TECHNICAL EVALUATION REPORT  
PILGRIM NUCLEAR POWER STATION  
STATION BLACKOUT EVALUATION

TAC No. 68585

Final  
January 14, 1991

U.S. Nuclear Regulatory Commission  
Washington, D.C. 20555

FIGURE 1  
ALTERNATE AC (AAC) CONFIGURATION  
NON CLASS IE DIESEL GENERATOR

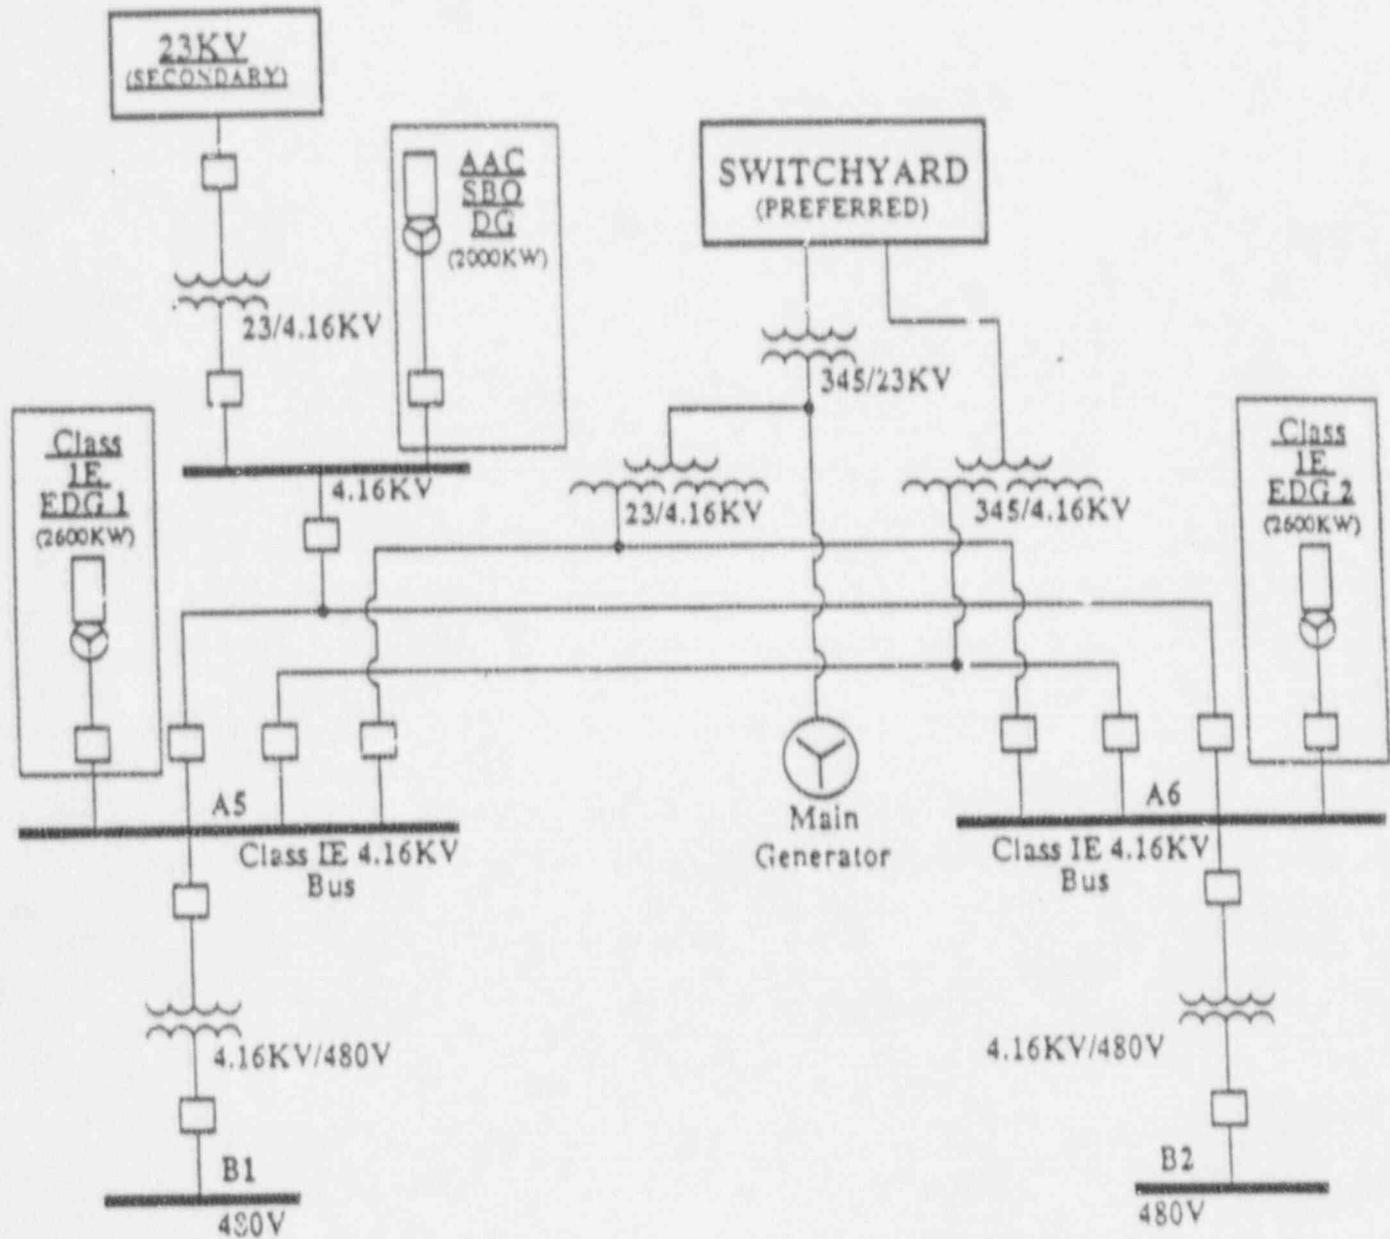
Based on information in the plant UFSAR, a telephone conversation on December 20, 1989, and the licensee's submittal dated August 31, 1990 (15), we conclude that the AAC power source (SBO-DG) meets all the criteria stated in Appendix B of NUMARC 87-00. However, there are two items that need further explanations or actions which are discussed below:

Availability After Onset of Station Blackout, Item B.9 This item checks the adequacy of the AAC power source in terms of capacity and capability to carry the SBO loads. Our review of Table B.5-1 of the plant UFSAR indicates that ~2000 kW of AC loads need to be supported after a LOOP event. This is almost equal to the SBO-DG capacity limit. However, in response to a question raised during the telephone conversation on December 20, 1989, the licensee provided a breakdown of the list of LOOP loads that are expected to be carried by one of the two EDGs. This list shows that the LOOP loads, including the short term loads, on EDG "A" and "B" to be 2,219.5 and 2,323.3 kW, respectively. Without the short term loads, the estimated continuous loads on EDG "A" and "B" are 2,080.9 and 2,184.7 kW, respectively. These loads exceed the SBO-DG capacity. The licensee stated (10) that the 4 kV control rod drive (CRD) pump (227 kW), and the 480 V loads that are not required during an SBO event will be shed. In addition, the licensee provided (15) a list of loads that are expected to be carried by the SBO-DG. The sum of these loads, according to the licensee, is approximately 1,750 kW. The 1,750 kW does not include the loads associated with the turbine generator auxiliaries, CRD pump, and the motor operated valves loads. Based on above, it appears that the SBO-DG will be able to carry the expected SBO loads.

Capacity and Reliability, Items B.10 to B.13 Items B.10 and B.11 are part of the SBO-DG reliability and surveillance program which need to be addressed by the licensee. Item B.12 asks the licensee to perform an initial test to demonstrate that the AAC system is capable of powering required shutdown equipment within 10 minutes of an SBO event. This test can be used to satisfy the requirement of item B.9. Finally, the licensee needs to provide a reliability program to ensure an SBO-DG reliability of at least 0.95 per demand as stated in item B.13. The licensee committed (15) to meet the guidance of B.10 through B.13 once the AAC-related modifications are completed.
